Access Compliance Report

Public Rights-of-Way (Curb Ramps)

Intersection ID: 17464	Main Street: FALLS_CREEK_LN	Cross Street: SCALEYBARK_RD	Location: E
ADA ID: BCD34ECC7EB6	Ramp Type: Perp	Initial Pass/Fail: Pass	Overall Compliance: No
Codes/Mitigation Info/Possible Solution		Field Measurements/Component Compliance

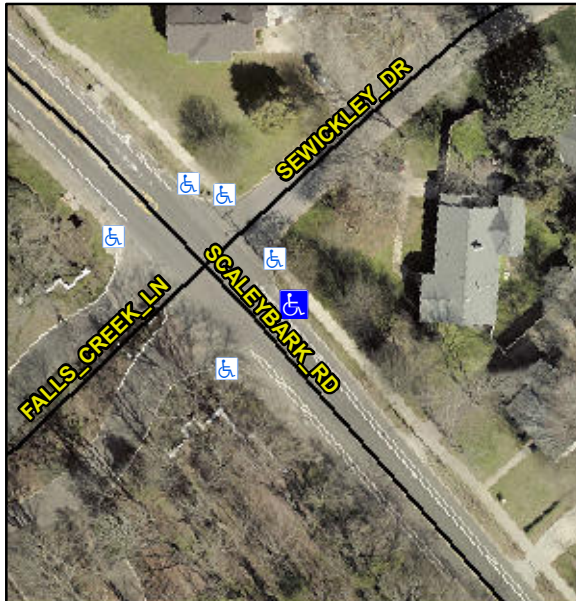
**Not Found, R304.2.2-Perp, R304.3.2-
Para, R304.5.4**

**Remove & Replace Entire Ramp.
Remove & Replace Gutter.**
